Trenton Robertson (Masterplan) Nicholas Balsamo (Kalterra)

Zoning Change (Case22-058)

Proposed phasing:

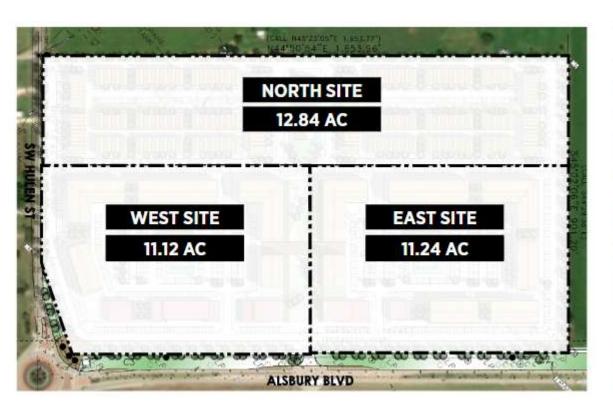
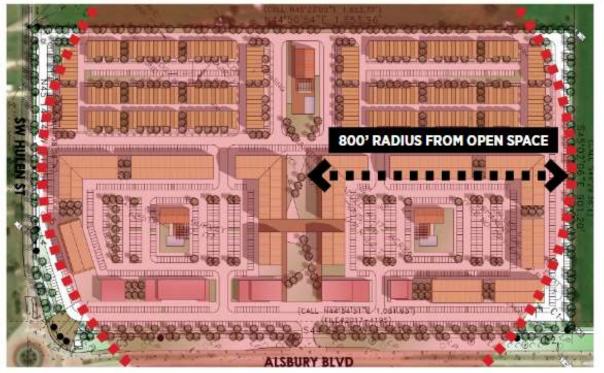
North Site would be Phase 1 with core Civic/Open Space required to be completed prior to issuance of any Certificate of Occupancies. Market would dictate whether West or East Site would be Phase 2.

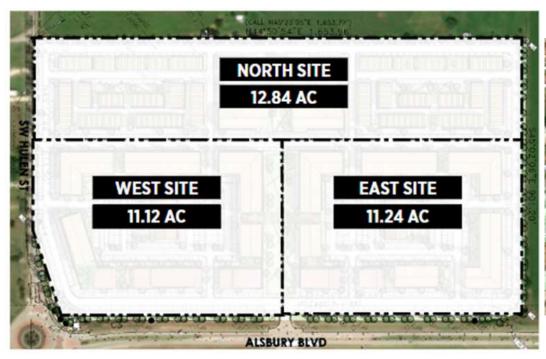
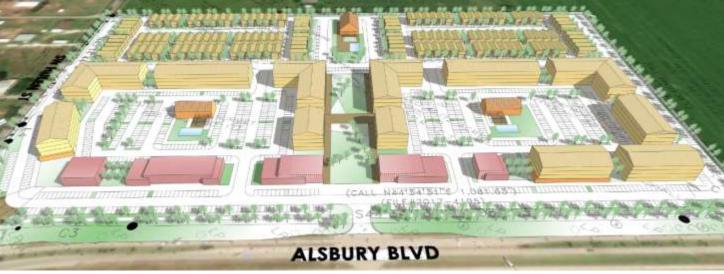
Overall -747 units total — 21.22 DU/acre

North Residential Site	East Residential Site	West Residential Site
10.28 dwelling units per acre	31.35 dwelling units per acre	23.61 dwelling units per acre
